DATE ~~R~~ Oct.15/03**V2500-A5/D5 SERIES PROPULSION SYSTEMS SERVICE BULLETIN**

This document transmits Revision 1 to Service Bulletin EV2500-72-0451 and
 Revision 1 to the Supplement

ENGINE – HIGH PRESSURE TURBINE FIRST STAGE DISK METERING PLUG REDESIGN

LOCATION OF METERING PLUG IN HUB ASSEMBLY TURBINE STAGE 1
Figure 1

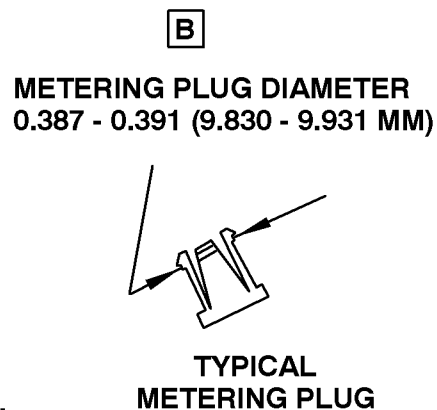
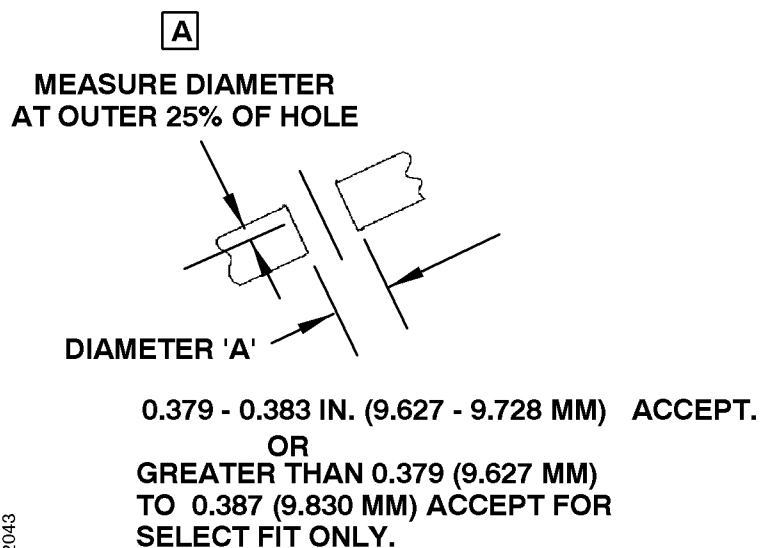
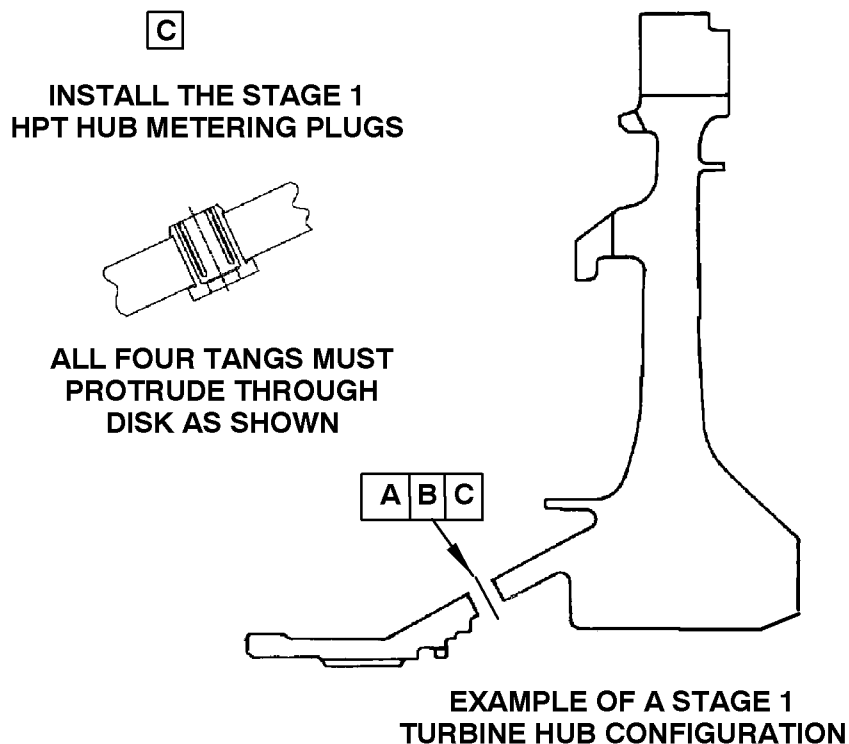
- (1) Remove the 1st Stage Disk Metering Plugs P/N 2A3182 (24 off) from the Turbine Rotor Assembly, 1st Stage (see Reference (5) Chapter Section 72-45-00).
- (2) Clean the Hub Metering Plug holes (24 off) in accordance with task 70-10-00-100-501.
- (3) Measure the Metering Plug holes in the Turbine Hub.
 - (a) If the hole diameter is between 0.379 in. (9.627 mm) and 0.383 in. (9.728 mm) accept and record the dimensions.
 - (b) If the hole diameter is greater than 0.383 in. (9.728 mm) to 0.387 in. (9.830 mm) accept part for select fit only and record the dimension. See Select Fit Chart.

- (c) If A. or B. does not apply, perform one of the following:
 - (i) If only one hole does not meet requirements in A. or B. identify the hole location, assembly requirements will allow one plug not to be installed if hole diameter is out of limits. This must be recorded in the engine build records.

- (ii) If more than one hole does not meet requirements in A. or B. contact IAE.
- (4) If all fits are acceptable, use IAE tool P/N IAE1P16495 or IAE1P17763 or other suitable drift to install and seat all 24 (or 23 depending on requirements reference 2. C. (1)) new stage 1 Metering Plugs through the rear bore of the hub into the inner diameter holes of the stage 1 Turbine Hub. Make sure the rear side of the Metering Plug tab touches the outer diameter surface of the Hub. See Figure 1.

SELECT FIT CHART

IF HOLE IS

USE PLUG 2A3847

0.383 in. (9.728 mm)	0.387-0.391 in. (9.830-9.931 mm)
0.384 in. (9.754 mm)	0.388-0.391 in. (9.855-9.931 mm)
0.385 in. (9.779 mm)	0.389-0.391 in. (9.881-9.931 mm)
0.386 in. (9.804 mm)	0.390-0.391 in. (9.906-9.931 mm)
0.387 in. (9.830 mm)	0.391 in. (9.931 mm)

FAMILY TREE – METERING PLUG, HPT 1ST STAGE DISK. REF. CATALOGUE SEQUENCE NO
72-45-11. FIG. 01 ITEM 040
Figure 2

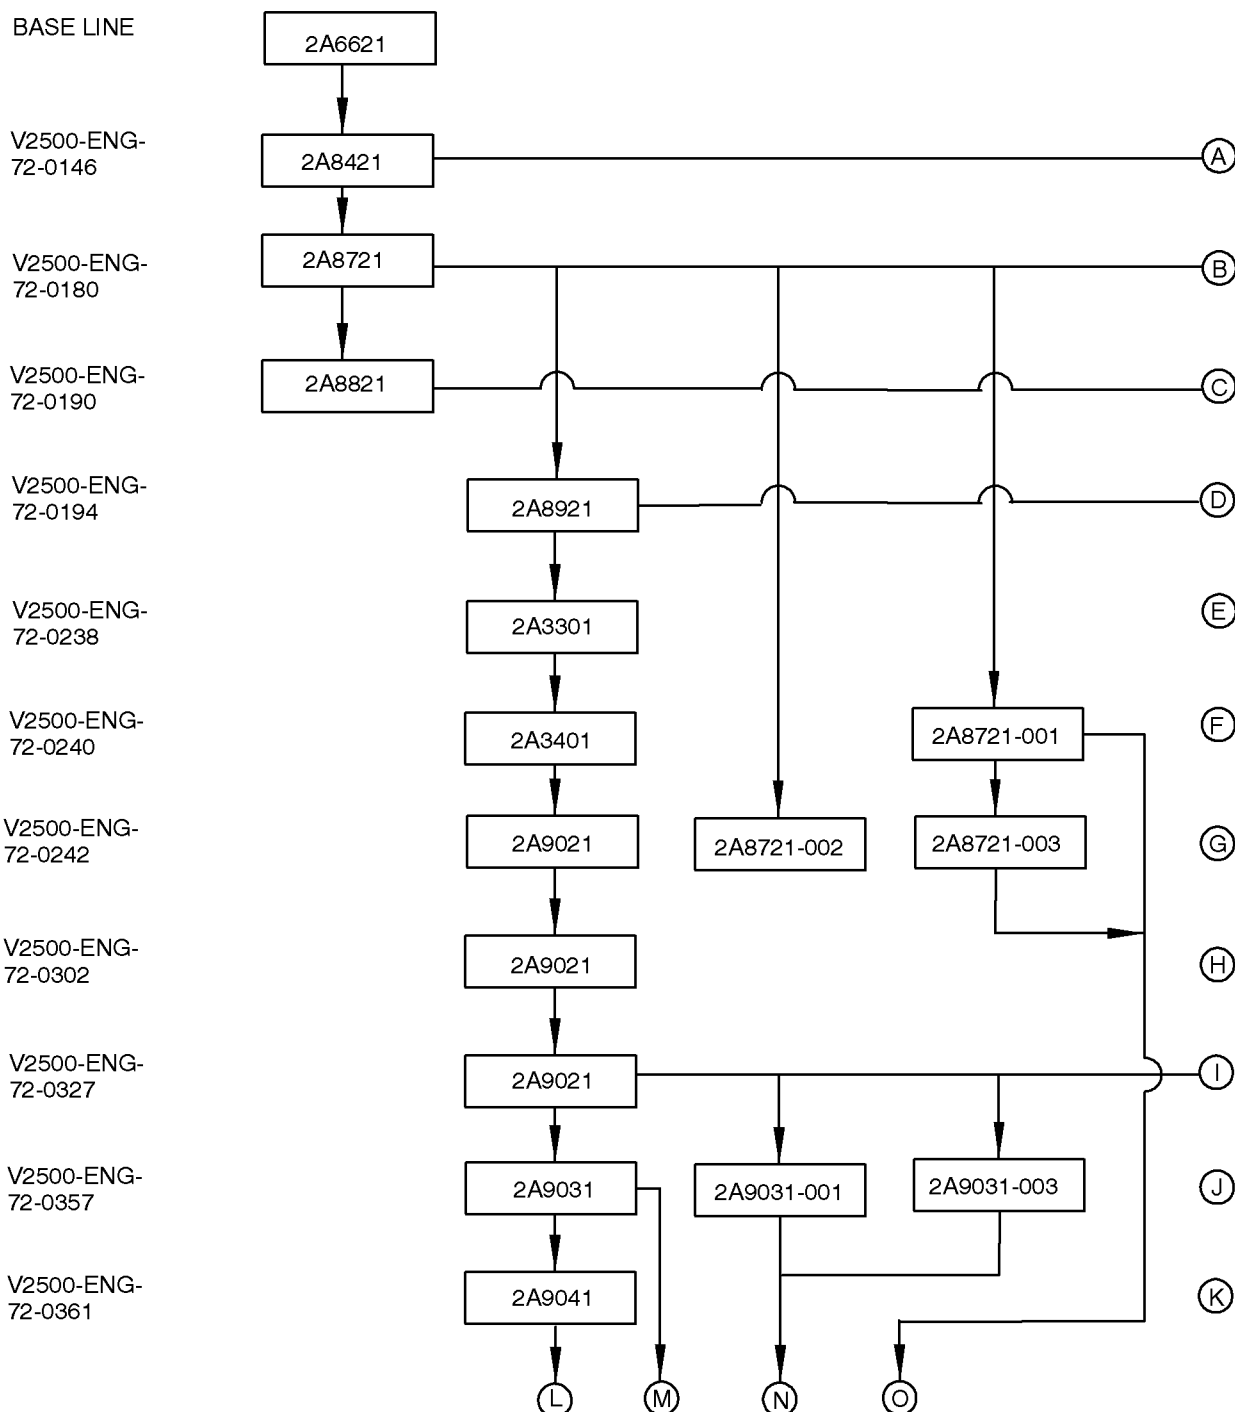
NOTE: Do not use Plug PN 2A2354 in Hub PN 2A5001.
